SUBJECT: **Addendum No. 1**
Caswell Enterprise Center
Yanceyville, NC

FROM: Ramsay Burgin Smith Architects, Inc.
225 North Main Street - Suite 501
Salisbury, NC 28144

ADDENDUM No.1
**BULLETIN
DRAWING**

SECTION @ RAMP

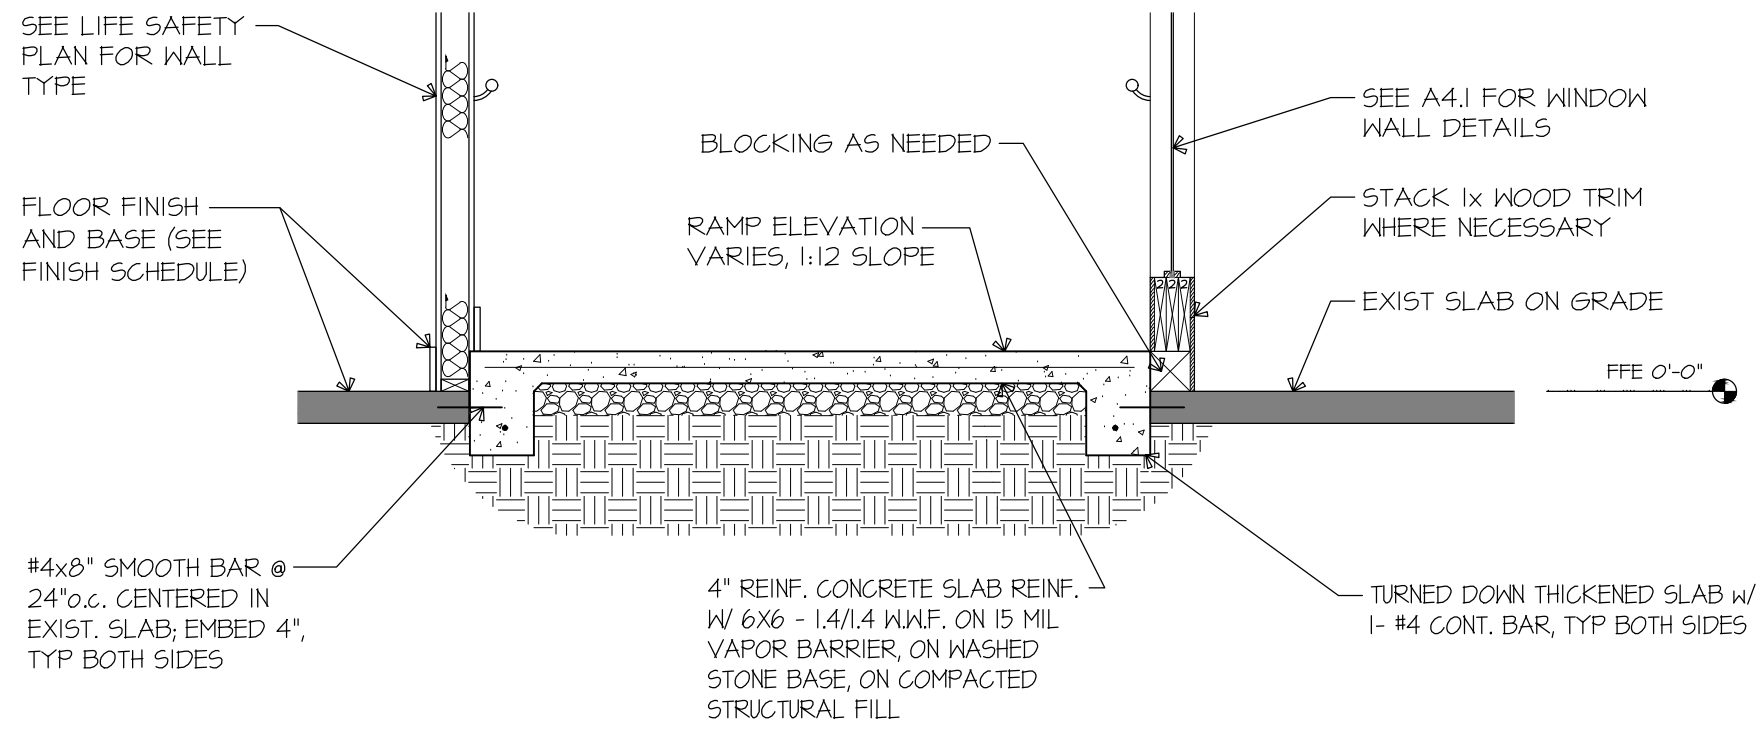
See attached Sheet ABD1.3 Section at Ramp and Sheet ABD1.4 Cross Section at Ramp, that details the new Handicap Accessible ramp configuration between the buildings negotiating the difference between the two finish floor elevations that is thought to be approximately 12”.
